# Customer Satisfaction Program

## 16019 HVAC Module Temp Door

Reference Number: N16202805

Release Date: October 2016  
Revision: 00

4585852

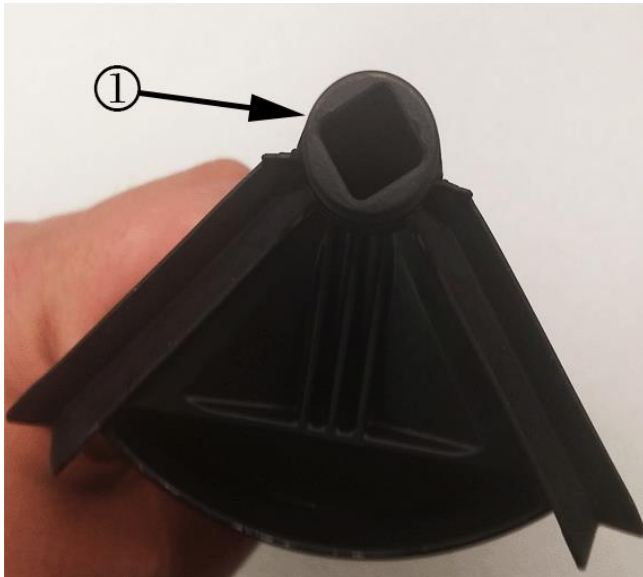
**Note:** It is not necessary to remove the temperature valve to add the clamp. Temperature valve removed for illustrative purposes only.

3. Install a #4 hose clamp over the temperature valve shaft as shown above.
4. Install the temperature valve actuator. Refer to *Temperature Valve Actuator Replacement* in SI.

4585859

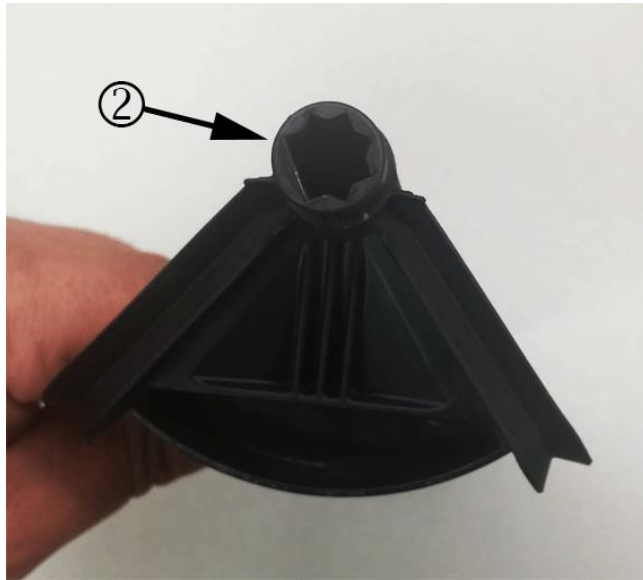
**Note:** A #4 hose clamp is NOT required with the star-D drive temperature valve.

- If the replacement temperature valve has a star D drive (2), the temperature valve actuator must also be replaced.
